Middleton Planning and Zoning Commission

Crescent Lake Subdivision

An application from Mineral Rights Leasing ID LLC for preliminary plat approval of Crescent Lake Subdivision. The proposed preliminary plat consists of 105 single-family dwellings on approximately 35.13 acres of vacant land located South of The Lakes Subdivision – Phase 1 on the West side of Kingsbury Road.

City Planning and Zoning Review Comments: See attached red-lined plans dated June 27, 2019.

**CRESCENT LAKE SUBDIVISION
CONCEPTUAL ENGINEERING PLAN**

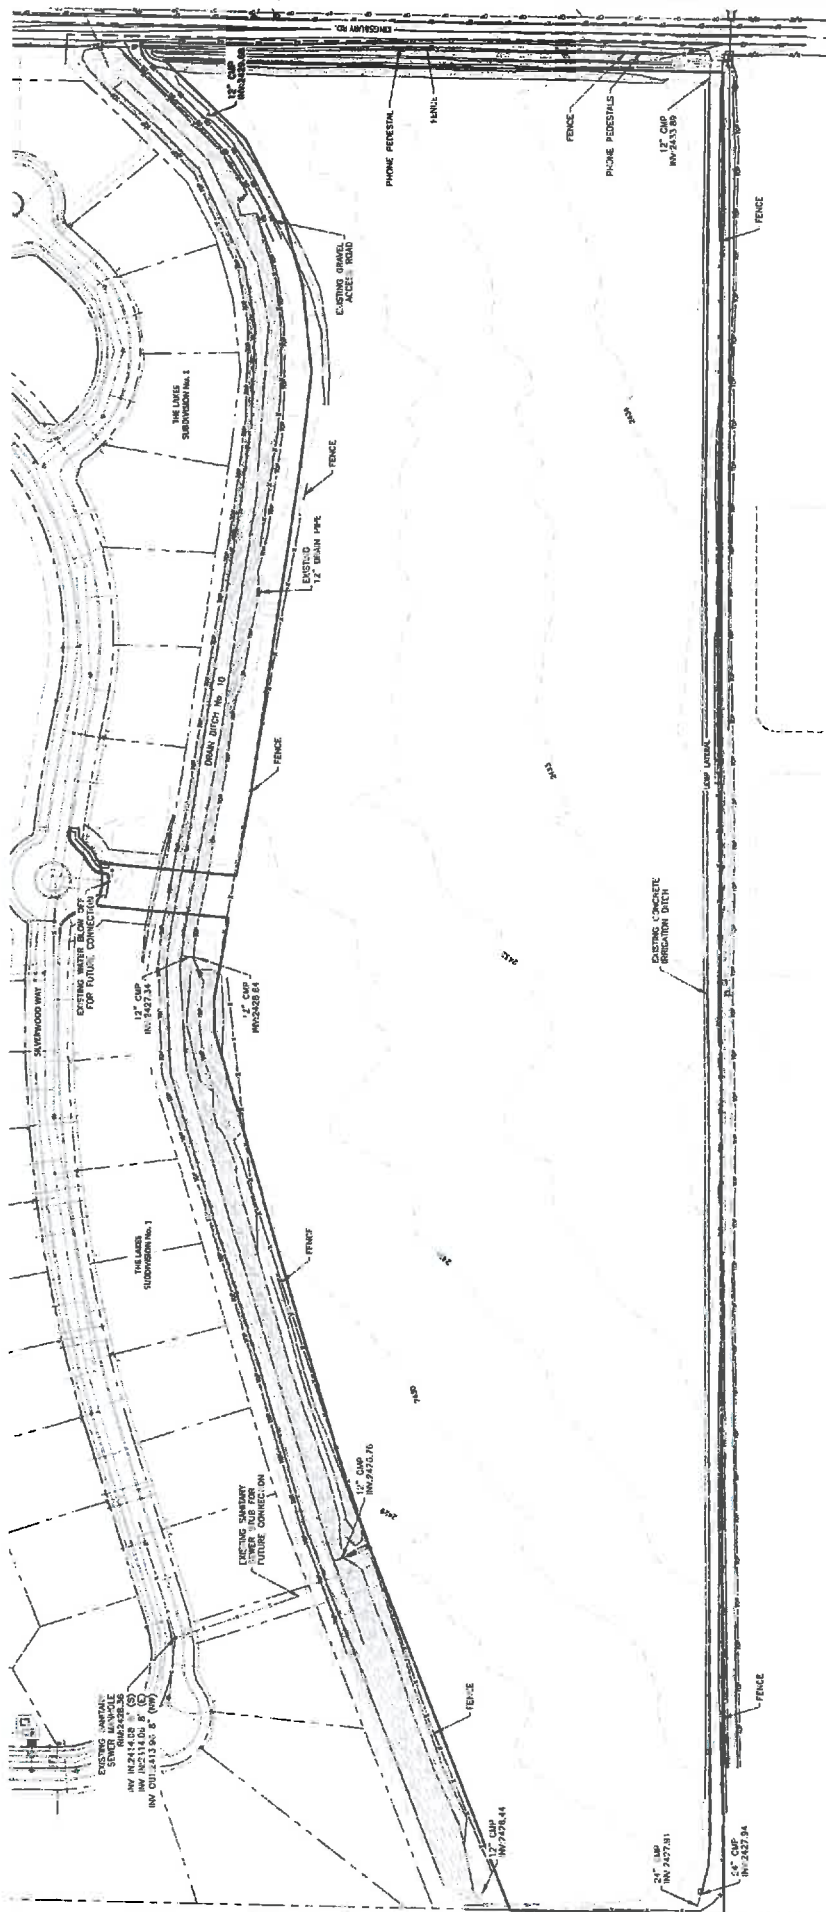
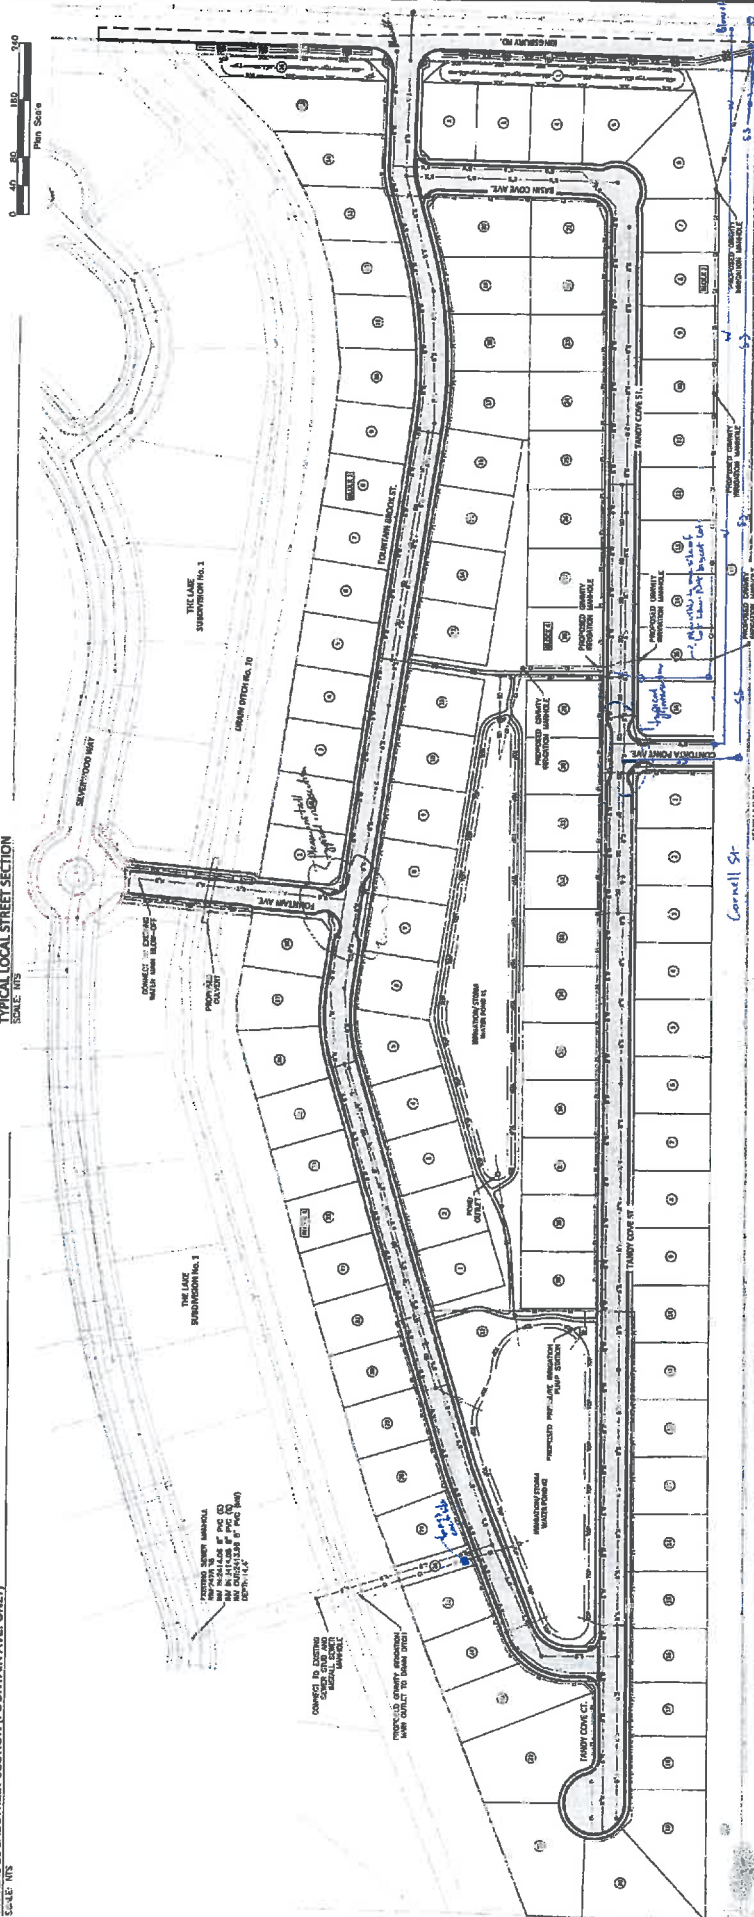
YOUR NARRATIVE SAYS WATER WILL BE CONNECTED TO PUBLIC SERVICES, HOWEVER PLAN PP3-0 STATES "DOMESTIC WATER SERVICE WILL BE PROVIDED BY THE LAKES SUBDIVISION HOA B" WATER MAIN".

Do not as much the water into existing groundwater/irrigation facility. Show water management to be system independent of irrigation need posttreatment

- (1) Add typical section from Kerns bridge.
- (2) These show base of section for units better paying for road.
- (3) Add typical section for South end of - show one or others important to road.
- (4) Place across 41 - middle back of the lot - on line with wing of lot 41.
- (5) Ingegnen cut at end of typical of 41.
- (6) Add section across ingenuen road - show values of 41 & 19 125'.
